ALLSTAR TECHNICAL NOTE

Product: Challenger S (AC9300) and Challenger GL (AC9500)

Subject: Operator Does Not Run Using Radio Control

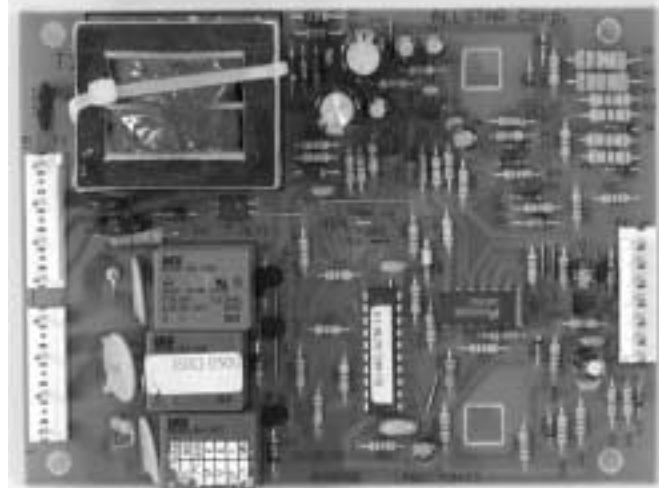
We have had some reports from customers that sometime after installation, the Challenger Operator stops working from the radio controls however continues to work properly from the wall button. Only a small number of operators have exhibited this problem. A picture of the subject control board is below.

Field returns and lab testing indicated that a component on the control board was being damaged. Under certain conditions, electrical noise from thunder storms, electrical appliances and other inductive loads could enter the control circuit, by way of the pushbutton wires, and damage electrical components on the control board. Further testing showed this problem could be virtually eliminated by upgrading a component on the control board. When tested in the lab, the control board with the new component withstood 3 times more voltage than the control board using the old component.

All products, including finished operators, replacement boards and warranty repairs, produced after June 27th will have the upgraded component installed in the control board.
